UNITED STATES PATENT AND TRADEMARK OFFICE

APPLICATION NO.	FILING DATE	FIRST NAMED INVENTOR	ATTORNEY DOCKET NO.	CONFIRMATION NO.
10/767,212	01/28/2004	Frederick J. Dojan	005127.00277	2583
22909	7590	09/01/2005	EXAMINER	
BANNER & WITCOFF, LTD. 1001 G STREET, N.W. WASHINGTON, DC 20001-4597			KAVANAUGH, JOHN T	
			ART UNIT	PAPER NUMBER
			3728	
DATE MAILED: 09/01/2005

Office Action Summary

FIG. 1

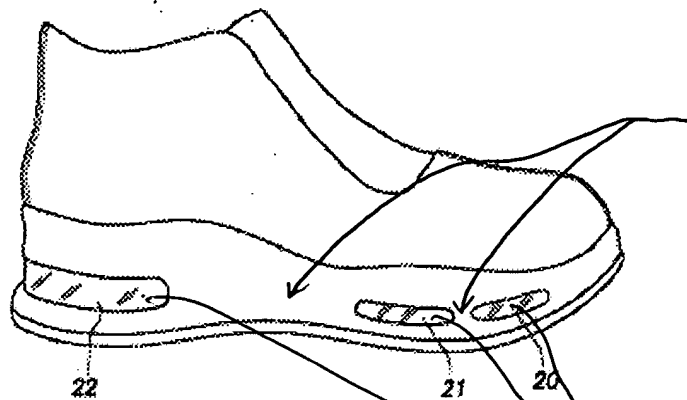
5. Claims 1-5,7-8,12,14-15 are rejected under 35 U.S.C. 102(b) as being anticipated by US 6009637 (Pavone).

Pavone teaches a sole component as claimed including a bladder and a reinforcing structure at least partially recessed into the barrier material as claimed. See the marked-up figures below.
